The Commission has issued the enclosed Amendments No. 17 and 14 to Facility Licenses No. DPR-33 and DPR-52 for the Browns Ferry Nuclear Plant, Units 1 and 2. These amendments are in response to your request of November 5, 1975, for authorization to plug the bypass flow holes in the lower core support plate and drill holes in the fuel assembly lower tie plates.

SAFETY EVALUATION BY THE OFFICE OF NUCLEAR REACTOR REGULATION
SUPPORTING AMENDMENT NO. 1⁷ TO FACILITY OPERATING LICENSE NO. DPR-33
AND AMENDMENT NO. 1⁴ TO FACILITY OPERATING LICENSE NO. DPR-52

BROWNS FERRY NUCLEAR PLANT UNITS 1 AND 2

FIGURE 1 Plug Installed in Core Support Plate

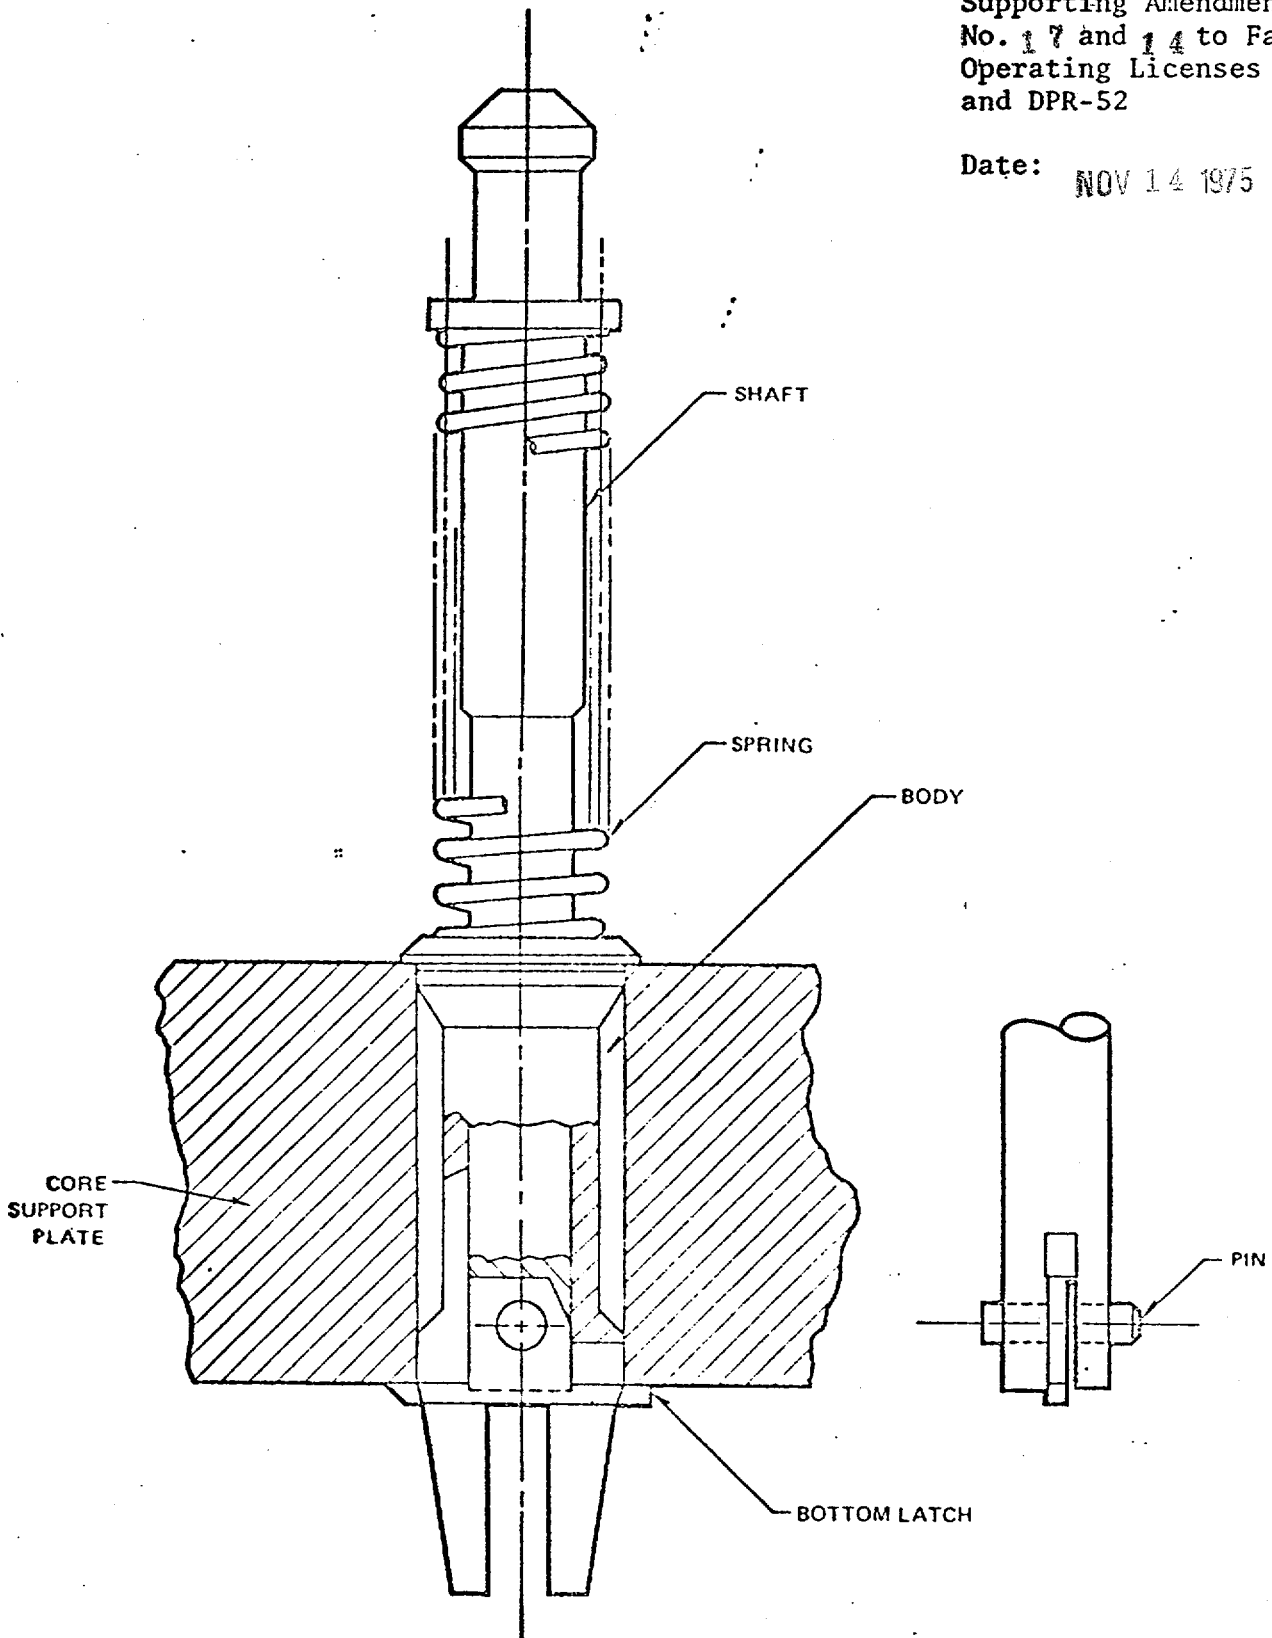
The plug consists of five basic parts, as shown in Figure 1. Identical plugs have previously been installed at Vermont Yankee, Pilgrim, Cooper, and Duane Arnold. The body provides a means of guiding the device into the bypass flow holes as well as a shoulder to support the plug and form a seal against water flow. The shaft extends through the body. A knob

is provided at the top of the shaft to provide a means of grabbing the plug during installation and extraction. At the bottom, the latch is attached to the shaft by a pin. The latch is free to rotate during installation. The spring acts against the body and shaft during normal operation to provide the force necessary to offset the pressure differential acting on the body.

During installation, the plug has its latch rotated 90 degrees from its installed position and withdrawn and locked in the body. The shaft is gripped by the installation tool, and the plug is inserted into the bypass flow holes. The body engages the rim of the hole. The shaft is pushed to its full extension, thus lowering and unlocking the latch below the underside of the core plate. The latch then rotates 90 degrees and bears on the bottom of the core plate. After insertion, the plug is pulled with about 30-pound force to test the placement. All fuel has been removed from Units 1 and 2. Therefore, the plugging operation involves no risk of fuel assembly damage and fission product release.

The plug can be removed by gripping the top of the shaft with an extracting tool and applying a force of about 500 pounds. The latch's legs will be plastically deformed and the entire plug withdrawn. The plugs previously installed at Vermont Yankee were removed with no abnormalities or loose pieces reported. The force required for removal varied from 500 to 1300 pounds.

Based on a review of the design, the installation methods and the previously successful operating experience at Vermont Yankee, Pilgrim, and Duane Arnold, we conclude that the plugs can be installed without damage to core components, that they will not fail during operation so as to result in loose parts in the core or result in unplugging of the bypass flow holes, and that they can be removed, if necessary, without damage to core components. The modification is thus reversible.

Accordingly, we conclude that the installation of the plugs is acceptable. The present license amendments, which authorize plugging of the core lower support plate bypass holes, do not authorize operation of the facility with these holes plugged. Such operation is not presently intended by the licensee and would be the subject of a separate licensing action if such operation is proposed. It is presently TVA's intention to complete the drilling modification, subsequent to our approval, prior to return to operation. This modification also will be the subject of a separate licensing action.
